U S NAVY RESPONSE TO SOUTH CAROLINA DEPARTMENT OF HEALTH AND
ENVIRONMENTAL CONTROL COMMENTS TO RCRA FACILITY INVESTIGATION
WORKPLAN AREA OF CONCERN 722 (AOC 722) ZONE I WITH TRANSMITTAL CNC
CHARLESTON SC
7/10/2003
CH2M HILL

AOC 722, Zone I
RtC RFZ Workplan (RD)

Re: CH2M-Jones' Responses to Comments by SCDHEC regarding the *RCRA Facility Assessment/RCRA Facility Investigation Work Plan, AOC 722, Zone I, Revision 0*

FIGURE 1
Locations of Proposed Wells I722GW001, I722GW002, and I722GW003
AOC 722, Zone I

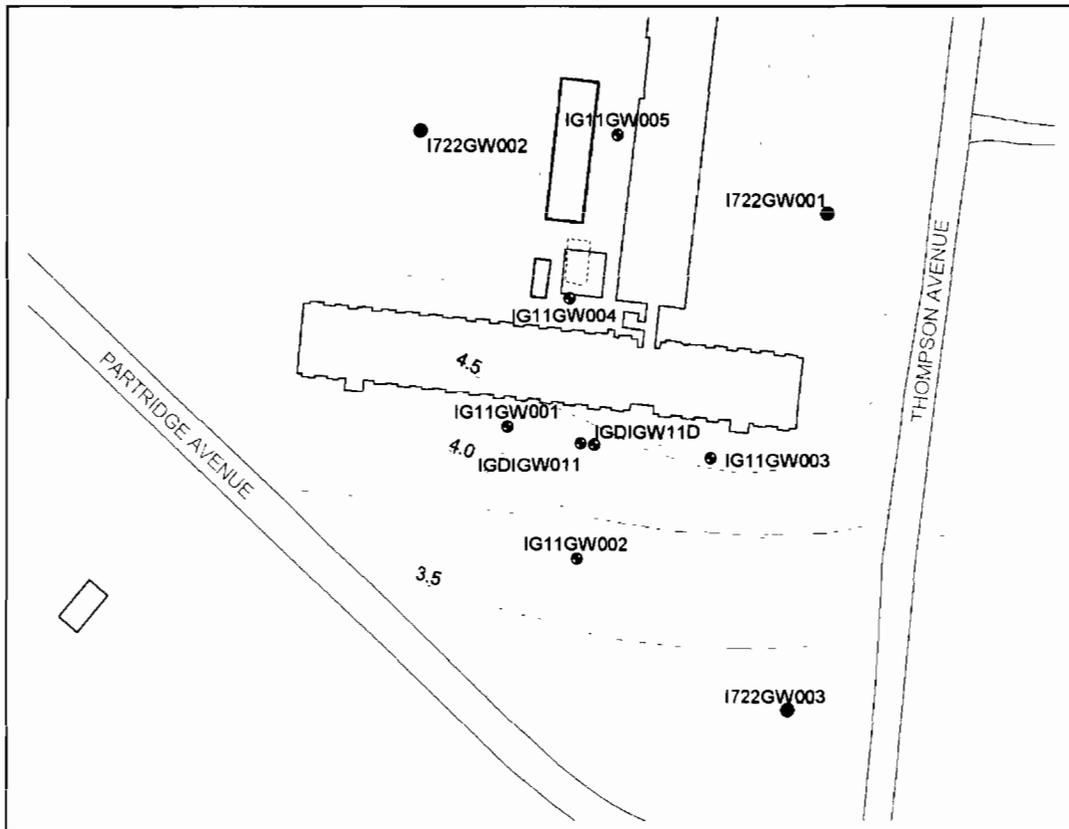
1. Figure 3.4

EGIS shows the shallow and deep groundwater flow to the northeast. This figure shows the shallow flow mostly to the south and failed to incorporate information from most of the site monitoring wells. The determination of the groundwater flow direction is essential in deciding a proper location for the proposed monitoring wells. Please revise and include a proper groundwater potentiometric map.

Conclusion: Approval of this Work Plan is contingent upon receipt of a monitoring well request and the potentiometric map that addresses these concerns.

CH2M-Jones Response:

The potentiometric contours in the EGIS are a regional groundwater flow interpretation from the basewide groundwater monitoring program, and are not intended to be highly accurate at the local site level. The shallow contours actually show both northern flow from south of AOC 722, and southern flow from north of the site, with low hydraulic gradients at AOC 722. The EGIS regional deep contours do show flow to the east toward Cooper River.

The localized shallow groundwater potentiometric map presented as Figure 3-4 of the RFI Work Plan was developed based solely on water levels measured at the site, and represents the most detailed and site-specific information available at this point, and thus is considered proper for initiating the RFI at AOC 722. The proposed monitoring well locations shown on Figure 3-5 of the RFI Work Plan will satisfactorily address your concerns about differences in local and regional groundwater flow as follows.

The first new well, located west of Building 1875, will serve as an upgradient well for regional eastward flow conditions across the AOC and will also detect any localized radial outflow from the unit; the second new well located east of Building 1875 will monitor groundwater in the regional downgradient direction (east) of the site; the third new well will monitor water quality in the local downgradient direction (south-southeast) of AOC 722.

The monitoring well installation request is being submitted separately; an updated version of the potentiometric surface map from Figure 3-4 is attached, showing the locations of the three new monitoring wells in yellow, along with existing well locations and local groundwater flow contours from March 2002.
